RE: Draft Environmental Impact Statement – Comments of mncoalgasplant.com

**DEIS IS INCONSISTENT WITH SCOPING DOCUMENT**

The Mesaba Project DEIS is inconsistent with the September 13, 2006 scoping document signed by the Commissioner of Commerce and there is no apparent scoping document by the DOE.

Diagram 1 – CapX 2020 Region

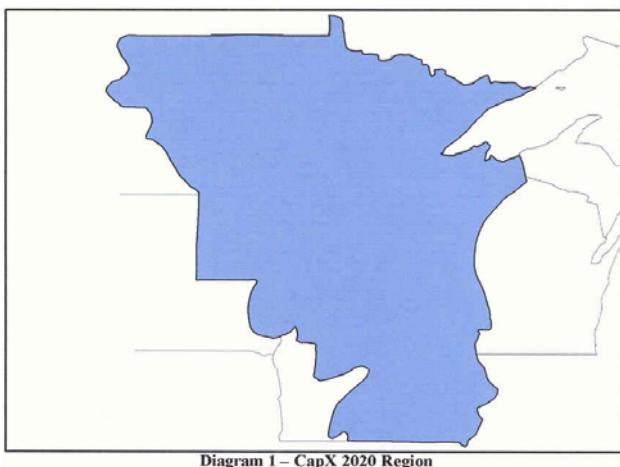
- 9) Section 1.4.2.1 accepts the project proponents’ claim of a “need within Minnesota for 3,000 to 6,000 MW of base load power generation over the next 15 years.” That is not substantiated, has not been independently verified, and it is not true – this “need” is a repeated exaggeration on the part of Excelsior Energy, and in the words of the PUC chair in November, specifically regarding Excelsior’s Mesaba Project’s projected generation, “No one needs it, no one wants it, and we’re not going to force it on anyone” or words to that effect.. The EIS must include substantiation of this claimed need. CapX 2020 claims a “need” for 4,500-6,000MW in the REGION, the shaded multi-state area below:
